RE: Bulli Seam Operations Project (MP 08_0150)
Appin Mine– Longwalls 709 to 711 and 905 Extraction Plan – request for additional information

I refer to your letter dated 7 March 2022, regarding the assessment of the Extraction Plan (EP) for Appin Mine's LWs 709-711 and LW 905 and the advice received from the Biodiversity Conservation Division (BCD) within the Department.

Figure 1 Surface water monitoring reconnaissance for the proposed longwalls.

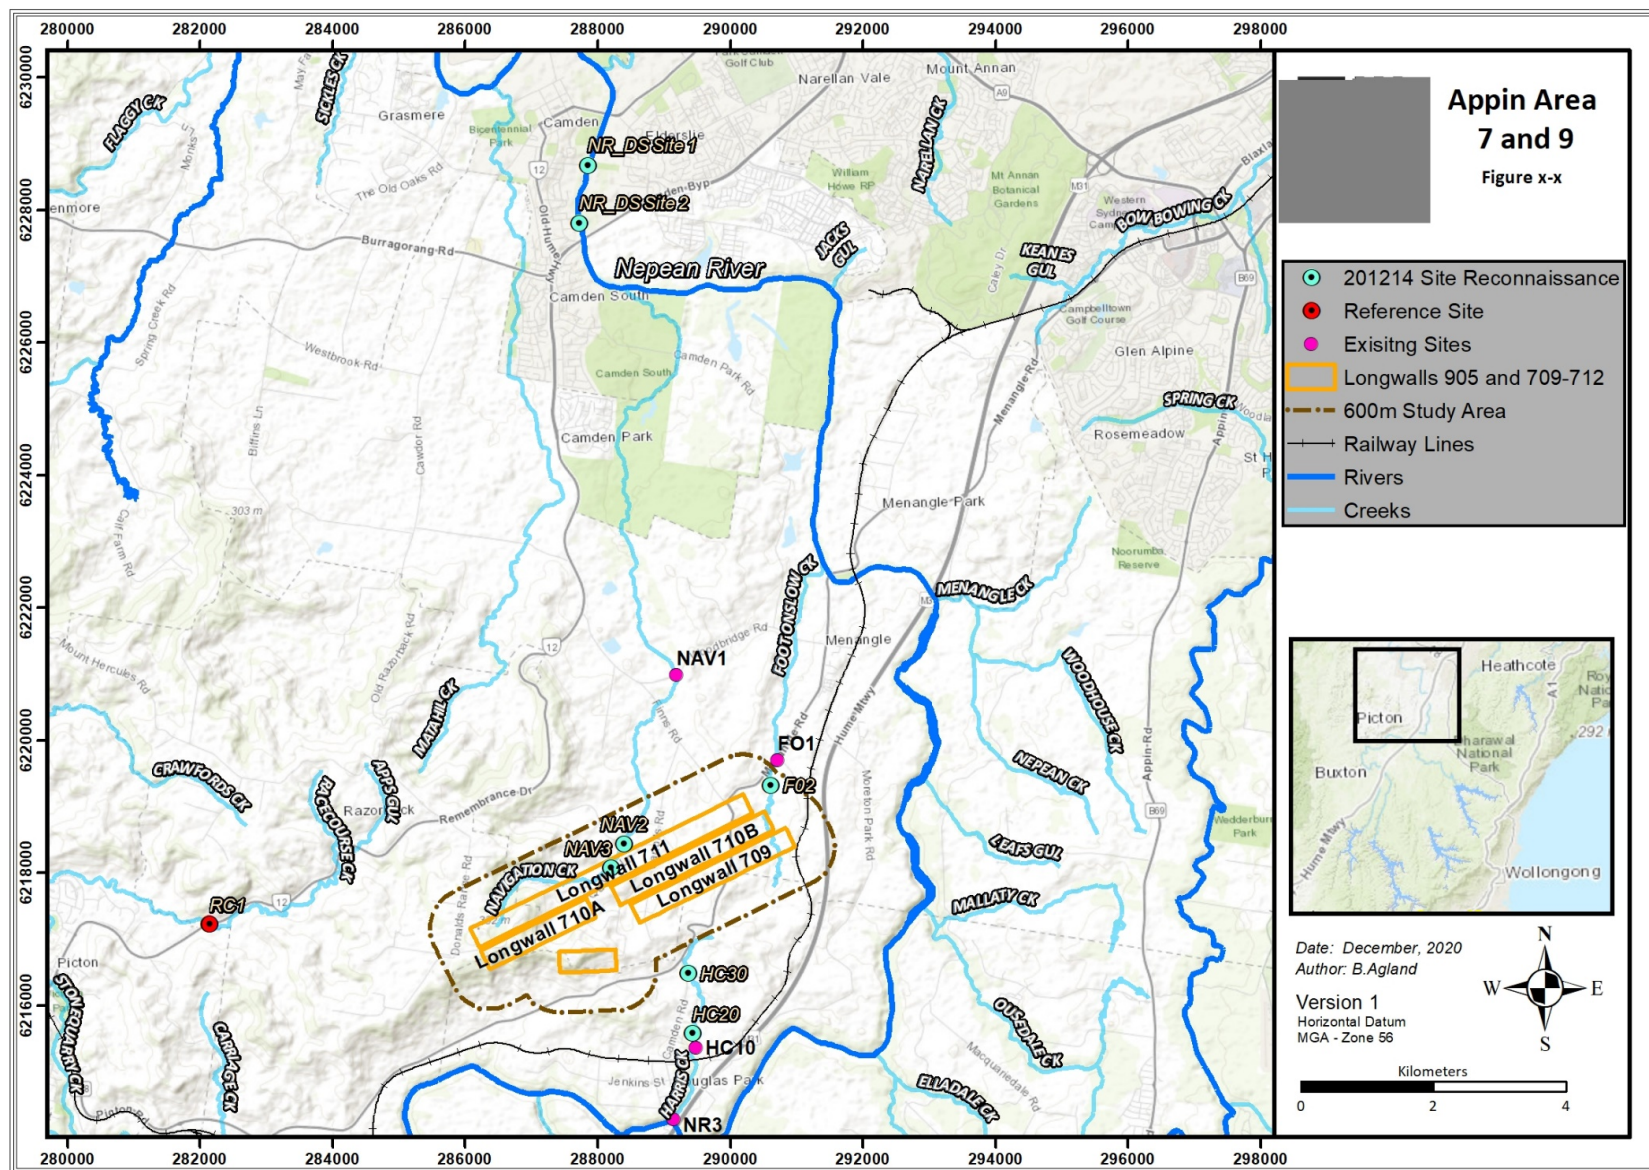
<p>Department requests that IMC consider expanding the existing monitoring program to include alluvial monitoring bores in third order sections of Navigation Creek, Navigation Creek Tributary 1 and Foot Onslow Creek that will be directly undermined and ensure that at least 12 months of data have been collected prior to extraction, wherever possible. Consideration should also be given to inclusion of piezometers over the longwalls.</p>	<p>Where access is granted, IMC will install pre and post extraction groundwater monitoring for the listed streams over the longwalls within the Hawkesbury Sandstone.</p>
5	<p>Surface Water Monitoring</p> <p>The surface water monitoring sites shown in Figure 8 of SLR (2021) and Figure 4 of SLR (2022) do not include any flow monitoring in watercourses or water level monitoring in pools over the proposed longwalls or at the existing NAV1, FO1 and HC10 water quality monitoring sites.</p> <p>The Department requests IMC update the existing monitoring program, or provide justification otherwise, for additional monitoring of flows and standing water levels in watercourses above and adjacent to the proposed longwalls.</p>	<p>Geomorphically, Navigation Creek, Foot Onslow Creek and Harris Creek are suitably characterised as an ephemeral chain-of-ponds system, particularly in the catchment where the proposed longwalls are located.</p> <p>Where these creek systems are located on private property, they are dominated by farm dams.</p> <p>Any surface water monitoring of these creeks, above the proposed longwalls, would essentially be reduced to monitoring the water levels of farm dams. IMC does not consider this to be a suitable monitoring strategy, given that landholders tend to use these dams (i.e. extract water).</p> <p>Monitoring sites above the proposed longwalls within sections of Navigation Creek and Foot Onslow Creek, on public property, were investigated during the development of the Extraction Plan application. Sites NAV2 and NAV3 (Figure 1), were investigated; no suitable sites for pool water level or flow monitoring were found.</p> <p>The existing site HC10 has suitable conditions for the installation of a water level benchmark and this will be installed.</p>
